## DEPARTMENT OF HEALTH &amp; HUMAN SERVICES

**BLA** 125426/0

**Subject:** Mid-Cycle Review Memo for the Biologics License Application (BLA)  
re-submitted- electronically January 27<sup>th</sup>, 2014 in response to the February  
1<sup>st</sup> 2013 Complete Response (CR) letter.  
-Original BLA submission received April 6th, 2012 (submitted by Inspiration  
Biopharmaceuticals)  
-FDA CR letter issued February 1<sup>st</sup>, 2013  
-Firm's Complete Response to February 1<sup>st</sup> CR letter - received January 27<sup>th</sup>, 2014  
submitted by Cangene Corporation in Manitoba, Canada

**Purpose of  
submission:** Resubmission of Biologics License Application for IXINITY™ (IB1001) as  
a complete response submission in response to FDA Complete Review  
letter of BLA STN 125426/0)

**Table 1.** List of F90 (b) (4) Batch ID and Lot Numbers included in this (b) (4) Assessment.

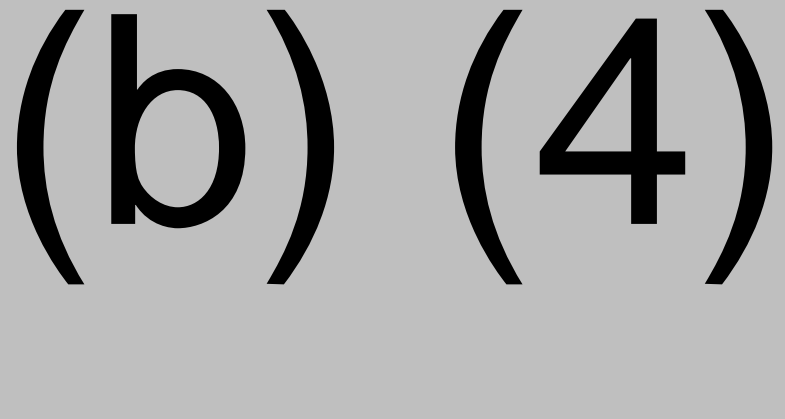
[VAL-30156-12 \(control-critical-steps-3.pdf\)](#) "F90 Continued Process Verification Annual Summary Report", lots (b) (4) summarizes manufacturing information for the lots manufactured with the modified process (in that a (b) (4) step is added). Associated lot numbers are identified in the table below.

#### **Cangene Response to Item 24c**

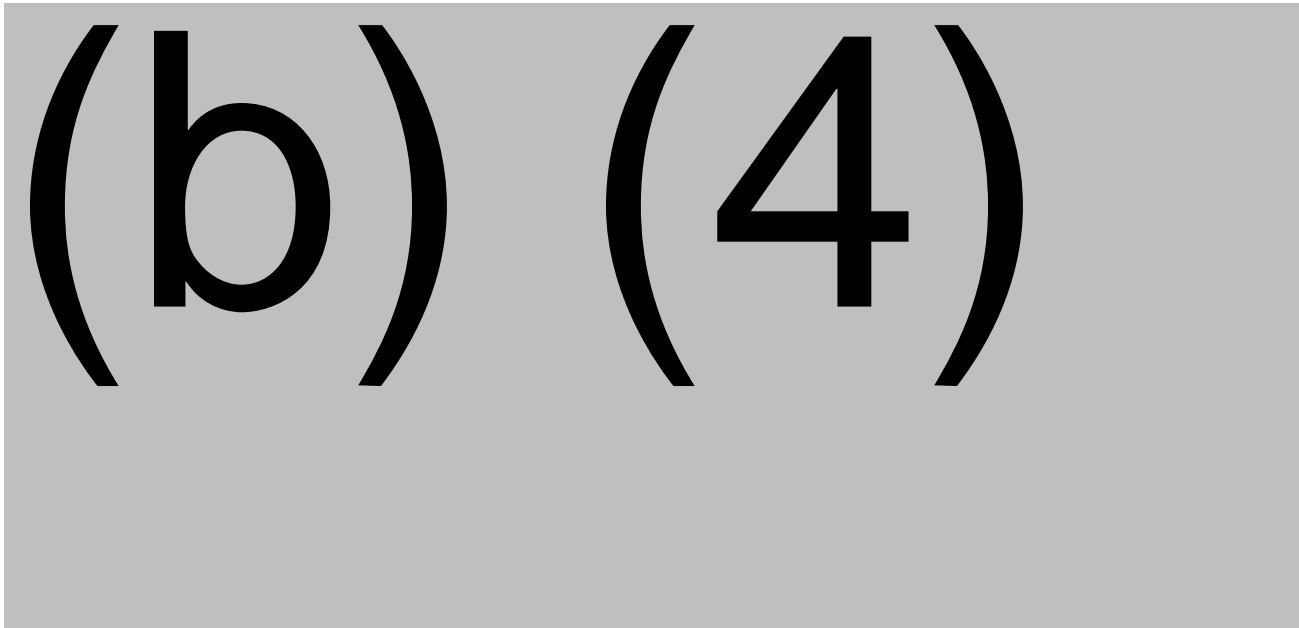
c. Your temperature mapping study at (b) (4) (included in Section 3.2.P.2  
Pharmaceutical Development) that supports the development of the lyophilization cycle  
does not include clear information on where thermocouples are placed on shelves and  
the correlation between product and shelf temperatures. Please indicate locations of  
the thermocouples per shelf and shelves used for the temperature mapping study and  
collapse temperature of the product and discuss any warm and cold spots identified,  
consistency of temperature readings and the relation between the product and shelf  
temperatures.

For transferring manufacturing of Drug Product (DP) to (b) (4) Site, the lyophilization parameters were identical to those developed by (b) (4) In this case, verifying only (b) (4) was deemed necessary on the laboratory scale lyophilizer. This was performed by (b) (4)
